# Woodward-Clyde Consultants

December 20, 1993  
87X4660

**Re: Proposed Background Sediment Sampling Locations for Round 1 of the  
Phase II Release Characterization of the Pawtuxet River**

PHASE II ROUND 1 RELEASE CHARACTERIZATION UPSTREAM REACH SEDIMENT LOCATIONS			
WOODWARD-CLYDE CONSULTANTS			
CONSULTING ENGINEERS, GEOLOGISTS AND ENVIRONMENTAL SCIENTISTS WAYNE, NEW JERSEY			
DR. BY	GT	SCALE	1" = 1200'
CK'D. BY	JR	DATE	SEPT 29, 1993
PRQJ.		FIG. NO.	
87X4660		4-1

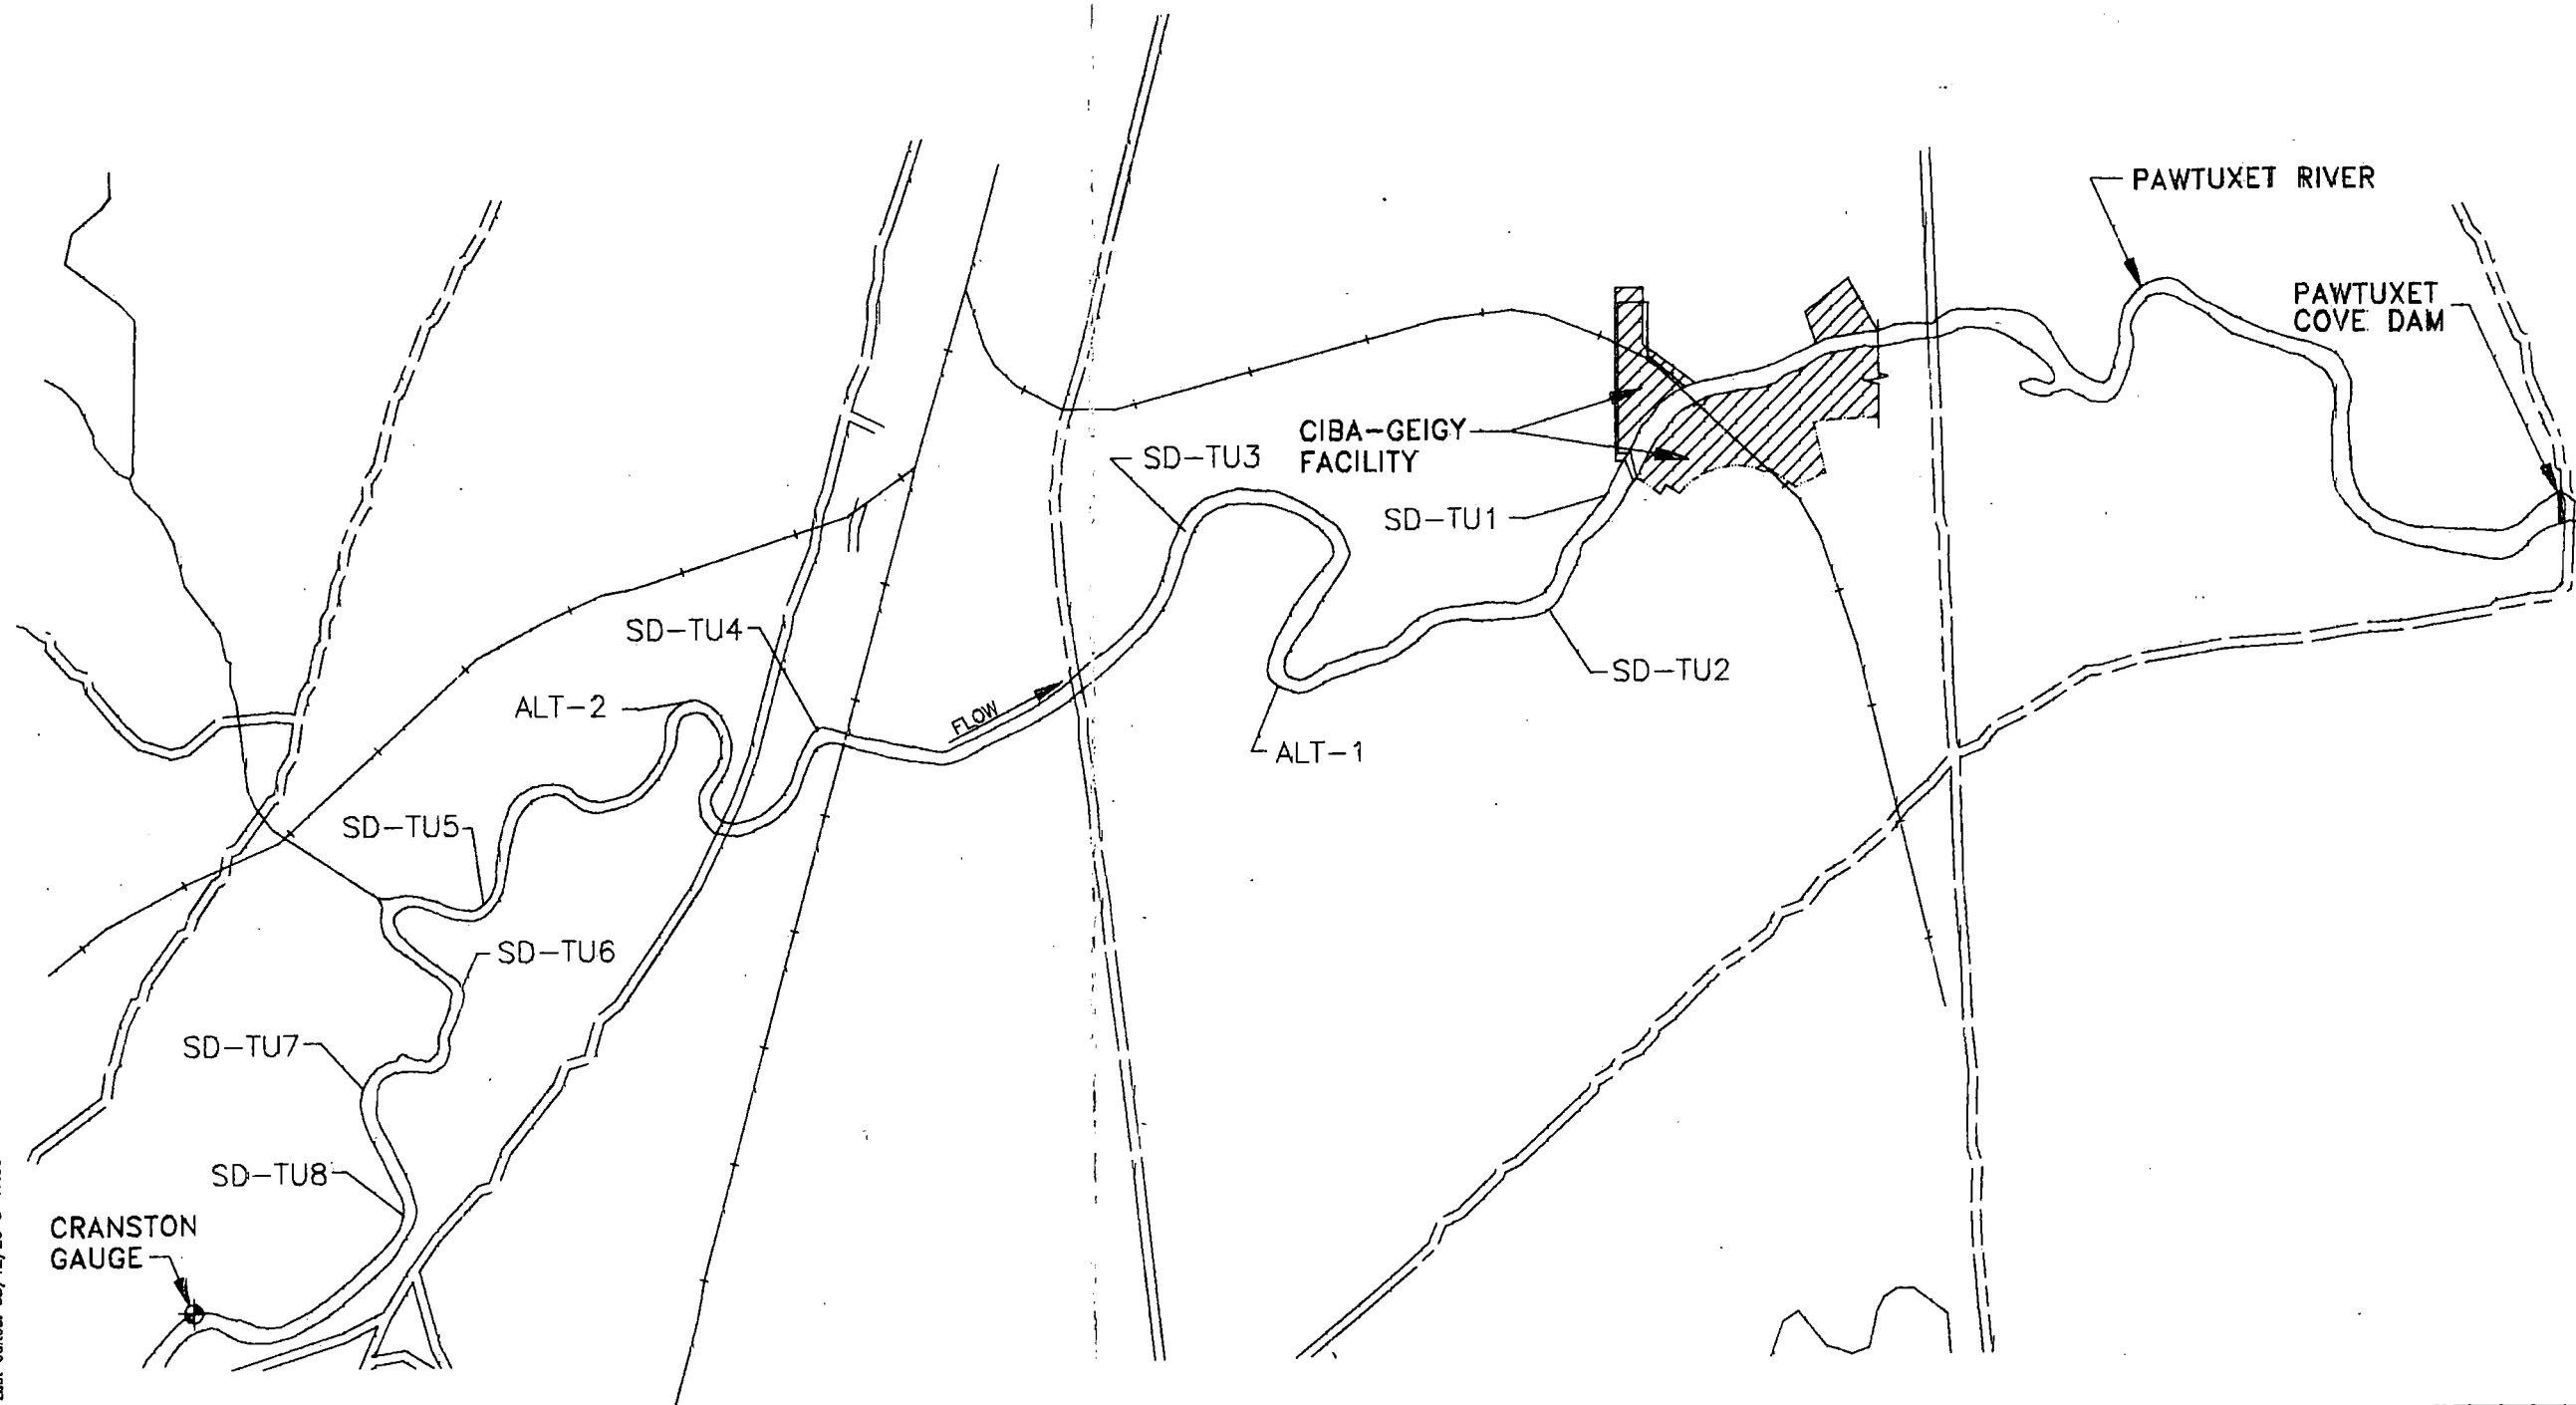
IDENTIFY THESE LOCATIONS  
IN REPORT
